## North Coast Regional Water Quality Control Board

Inspection Report  
Stanshaw Creek Diversion  
Marble Mountain Ranch  
Douglas and Heidi Cole, Landowners  
92520 Hwy 96, Somes Bar  
Siskiyou County  
WDID No. 1A15024NSI

Date: March 9, 2015

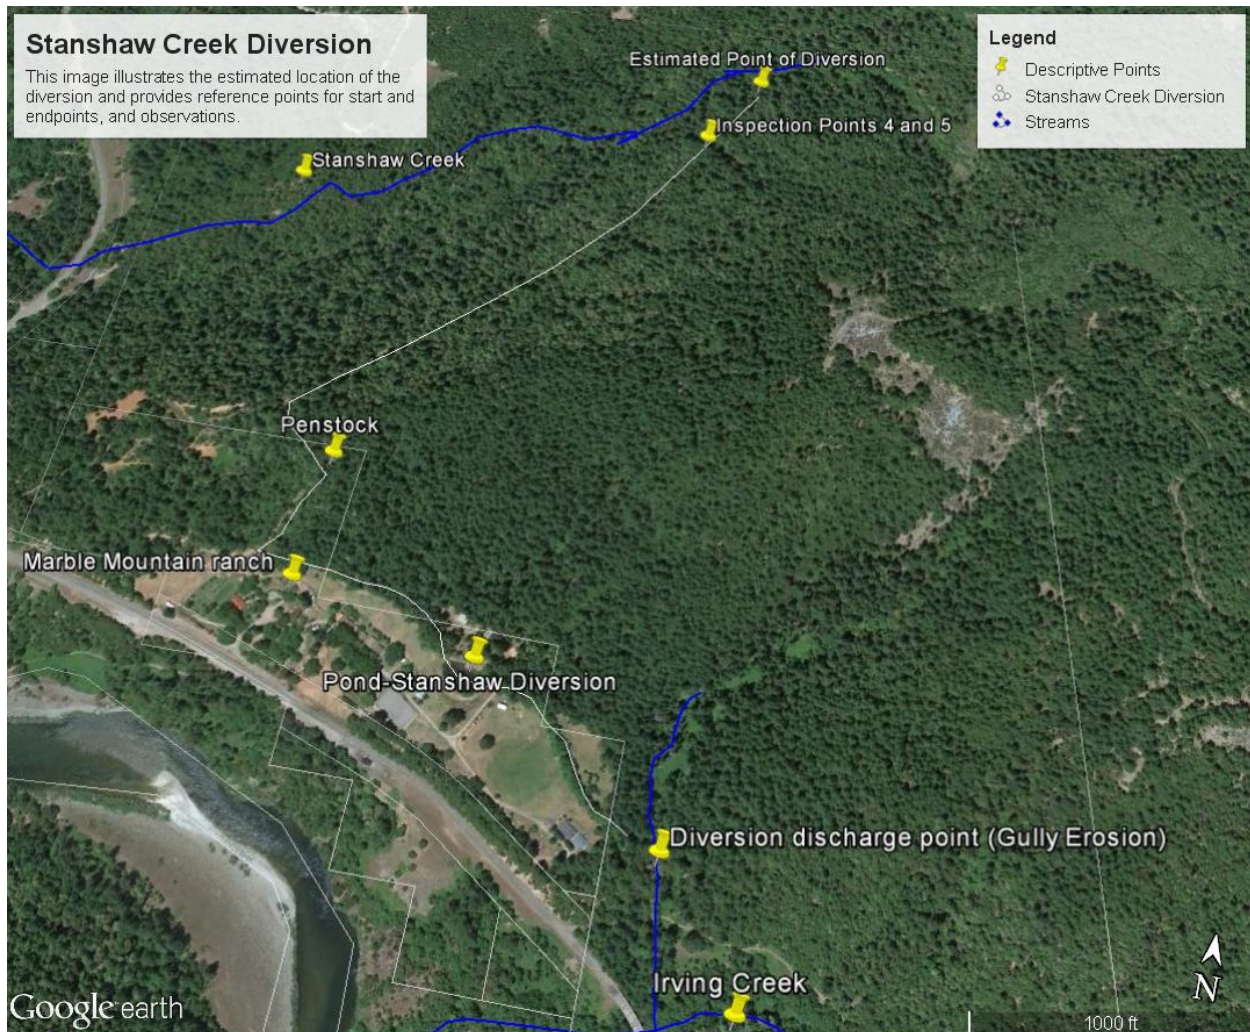
As discussed below, at inspection Points 4 and 5, and visible in image 1, the upper ditch crosses over an unnamed tributary to Stanshaw Creek. The tributary is conveyed under the ditch via culvert. At this location, there is also a culvert that drains a portion of the water in the ditch and discharges it through a shotgunned outlet onto the slope a short distance below the outfall for the stream crossing culvert. The combination of uncontrolled discharges and additional flows into the unnamed tributary has caused significant streambank erosion and channel widening in the tributary downstream of the culvert. The ditch may have historically failed at this location, which has likely also contributed to stream channel enlargement.

Image 1 provides general locations for the Point of Diversion at Stanshaw Creek (Point 1), and the discharge point above Irving Creek (Point 20), which are the start and end points of inspection observations as ordered below.

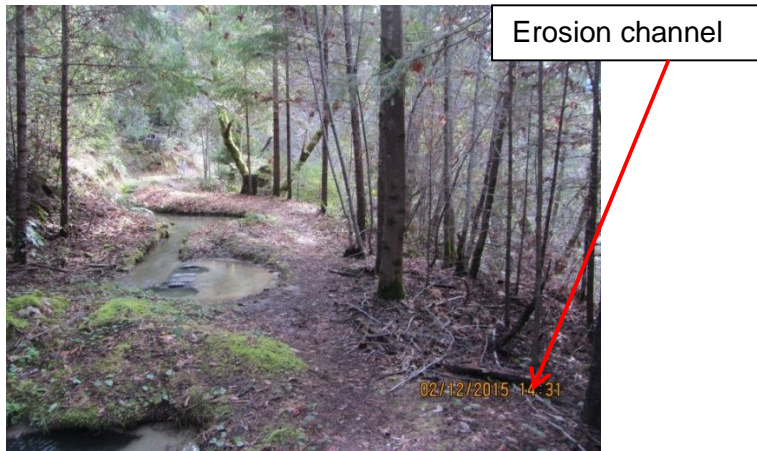
Image 4- shows Point 2, a failure along the outboard berm, approximately 70 feet downstream of Point 1, allowing some of the water in the ditch to flow down to Stanshaw Creek, potentially resulting in erosion and sediment transport. This location appears to have failed repeatedly in the past. The instream flume in the Ditch just downstream of this failure is used to measure flows entering the diversion. (Photo 8454 and 8455)

Image 9- at Point 5, shows the shotgunned 12-inch ditch culvert outlet, diversion ditch and native stream channel flowing under the diversion ditch. (Photos 8442, 8443, 8444, 8445 composite)

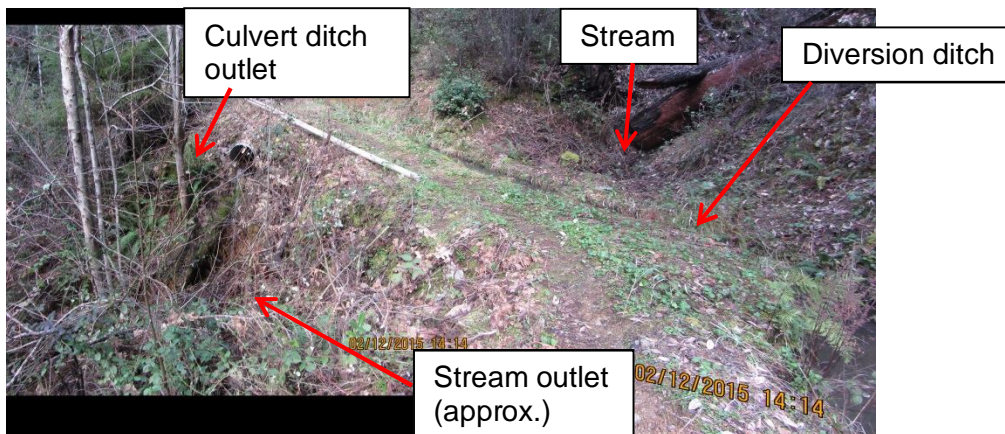
Image 10- shows the unnamed stream channel above Points 4 and 5; the upslope active bankfull stream channel width is approximately 3-4 feet.

For either alternative, the ditch repair or decommissioning plan shall include specifications to restore the affected stream/unnamed tributary that crosses at inspection points 4/5, replant with native vegetation, and to protect streams from any further impacts or discharges associated with the ditch.

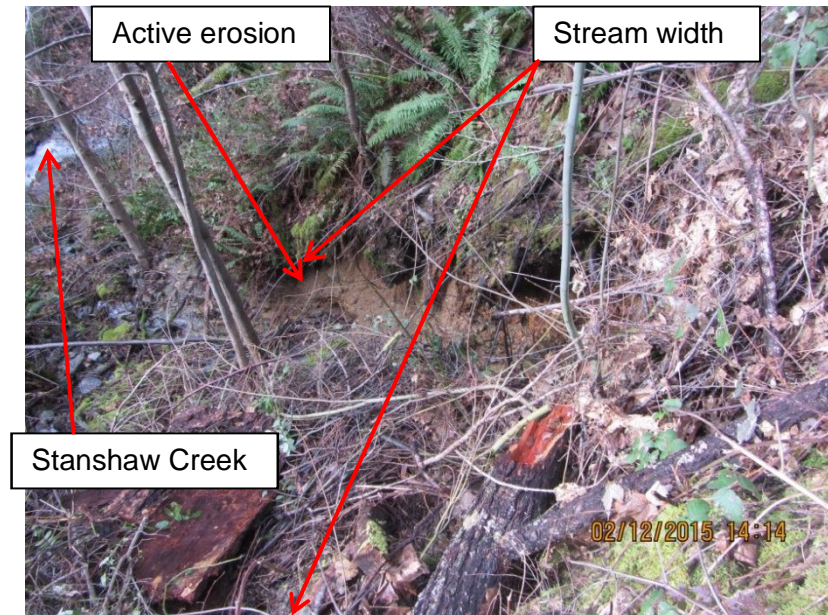
Image 11- shows the unnamed stream channel downstream of Point 5, and the erosion caused by water draining from the shotgunned culvert. Stanshaw Creek can be seen a short distance downslope. I conservatively estimate that this site has delivered 150-300yds<sup>3</sup> of sediment and debris to Stanshaw Creek over the life of the Diversion. (Photo 8478)

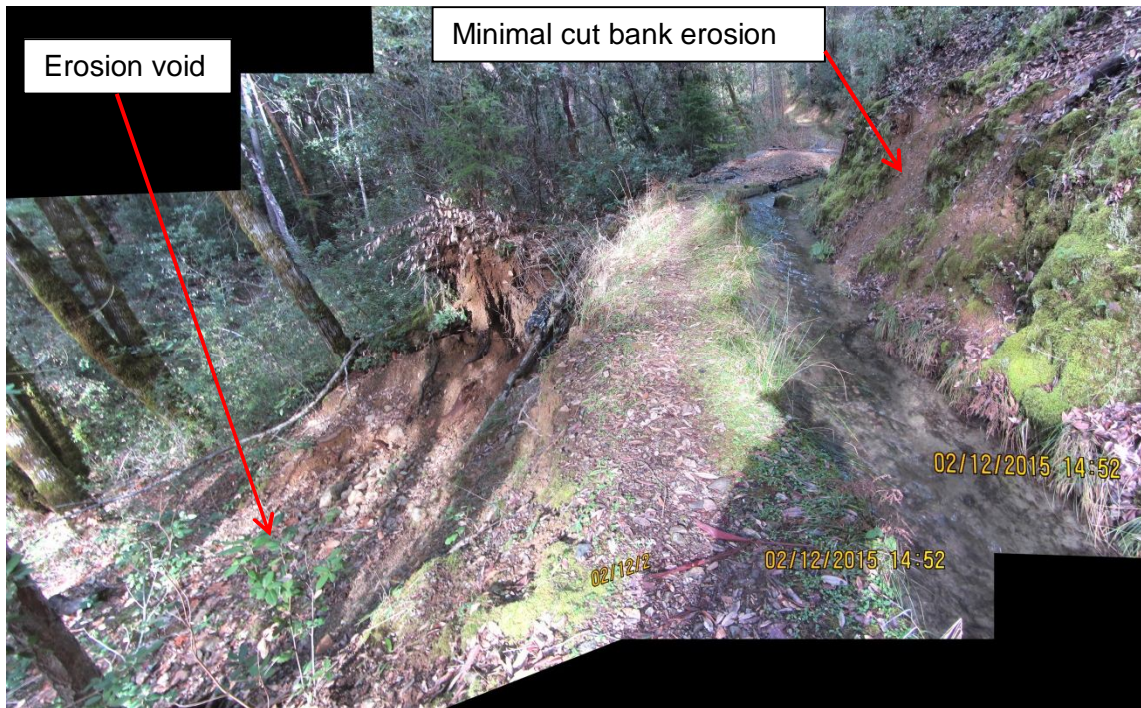
Image 16- Point 10 is an area of concern that includes an erosional channel likely formed by a berm failure and active erosion visible on the cut bank. I observed active cut bank erosion on many of the upper slopes above the diversion ditch and expect that bank slumps have and are contributing significantly to ditch failures. (Photos 8495, 8496, 8497, and 8498 composite image).

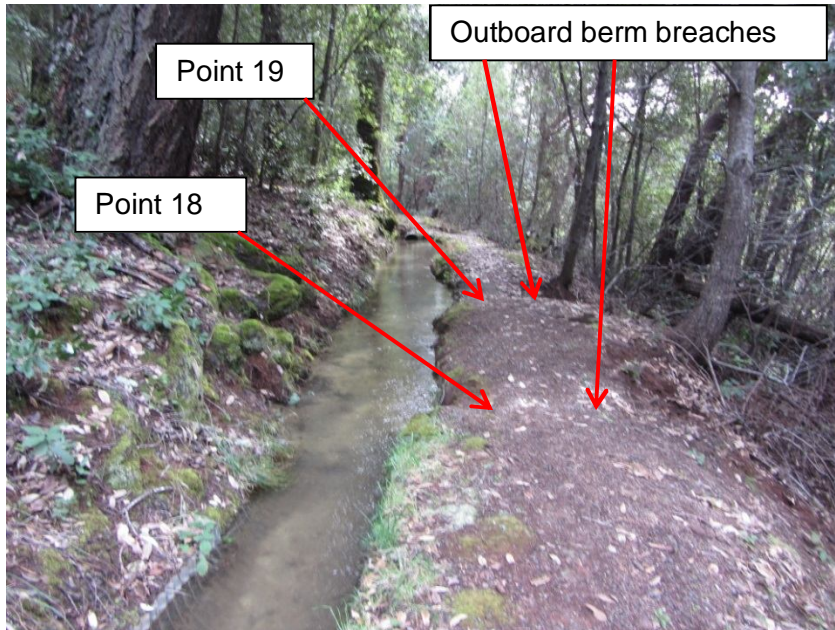
Image 25- shows two locations, points 18 and 19, where the outboard berm has apparently breached in the past, resulting in gully erosion on lower slopes. The failure at Point 19 resulted in the formation of a gully channel for a long distance down the slope, and may have contributed a significant sediment load to the Klamath River and possibly Stanshaw Creek. I did not follow the gully all the way down the slope, but did see an erosion channel from the lower road.
